NOV_SCE_EDC_ 20211208-01

NOTICE OF VIOLATION

Energy Safety Inspection Report

Report Name: SCE_EDC_20211208

Structure ID: 1008929E

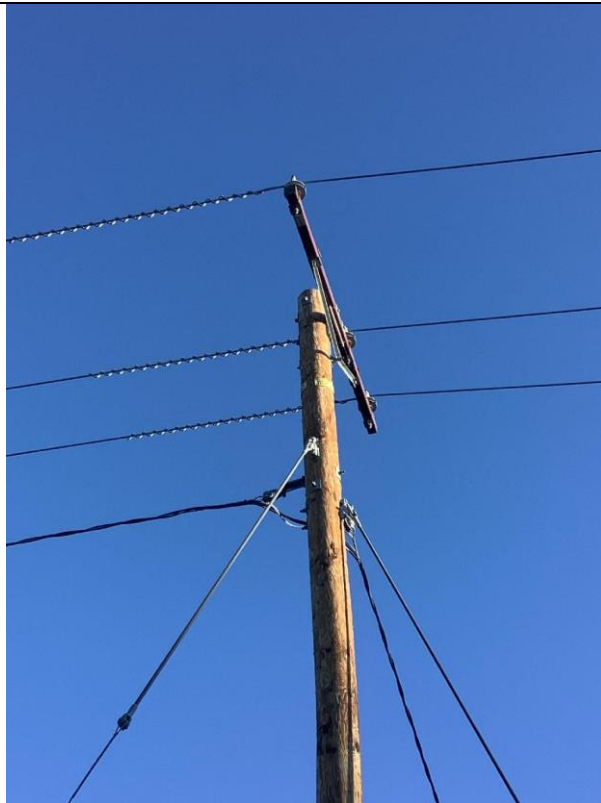
Item2IA1img1: Vibration damper within 6 inches of insulator

Per SCE's Distribution Overhead Standards (DOH), Section CC 190, page 3 of 11, the vibration damper must be installed to maintain a minimum of 6 inches away from the splice on the opposite side to the structure, or on the other end of the span.¹ These structures are noted in table 2 above.

Structure ID: 783316E

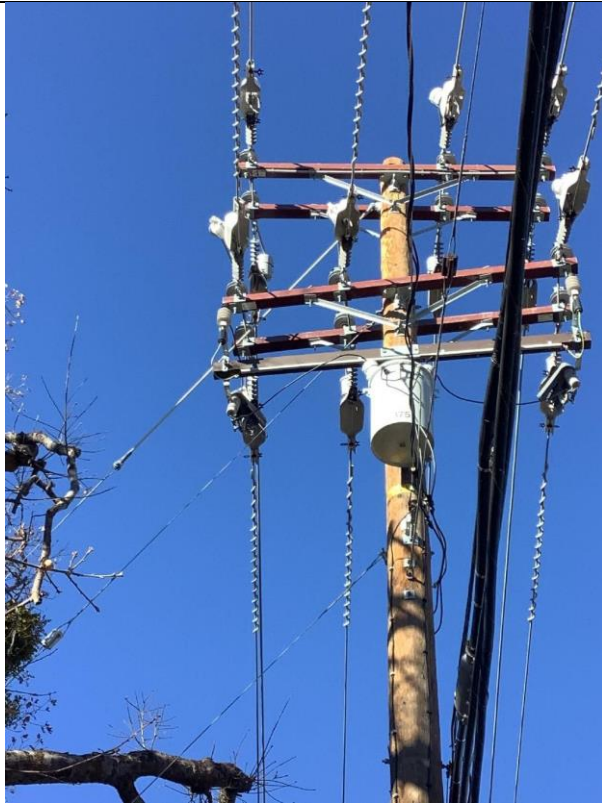
Item3IA1mg1: No fiberglass guy insulator installed at the secondary level
